# Access Compliance Report

## Public Rights-of-Way (Curb Ramps)

Intersection ID: N/A	Main Street: PERIWINKLE_HILL_CT	Cross Street: N/A	Location: W
ADA ID: CCDFB8D68C81	Ramp Type: Perp	Initial Pass/Fail: Pass	Overall Compliance: No
Severity Score: 0			
Codes/Mitigation Info/Possible Solution		Field Measurements/Component Compliance

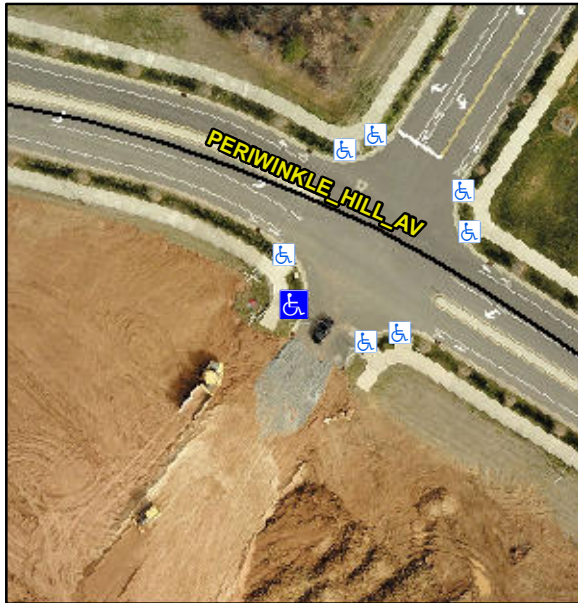
**Not Found, R305.2**

Compliance	Description	Data	Compliance	Description	Data
N/A	Ramp Length (in)	99.0	Yes	Ramp Slope (%)	8.0
Yes	Ramp Width (in)	91.0	Yes	Ramp XSlope (%)	0.3
Yes	Flare Type L	Curbed_NoWalkSurface	Yes	Flare Type RT	N/A
Yes	Flare Slope LT (%)	N/A	N/A	Flare Slope RT (%)	N/A
N/A	Flare Traversable LT?	No	N/A	Flare Traversable RT?	No
Yes	Landing Length (in)	96.0	Yes	DWS Provided?	Yes
Yes	Landing Width (in)	64.0	Yes	DWS Contrast?	Yes
Yes	Landing Slope (%)	1.6	Yes	DWS Length (in)	24.0
Yes	Landing X Slope (%)	1.0	Yes	DWS Full Width?	Yes
N/A	Landing Curb? (Y/N)	No	No	DWS Offset (in)	3.0
N/A	Shared Landing?	No			
Yes	Gutter Ponding?	No	Yes	Gutter Slope (%)	0.6
Yes	Gutter Lip Ht (in)	0.0	Yes	Gutter X Slope (%)	0.7
N/A	Painted X Walk1?	No	N/A	Painted X Walk2?	N/A
	X Walk 1 Direction	To SE		X Walk 2 Direction	N/A
N/A	X Walk 1 Width (in)	N/A	N/A	X Walk 2 Width (in)	N/A
	X Walk 1 Slope (%)	7.0		X Walk 2 Slope (%)	N/A
	X Walk 1 X Slope (%)	3.4		X Walk 2 X Slope (%)	N/A

**Remove & Replace Entire Ramp.**
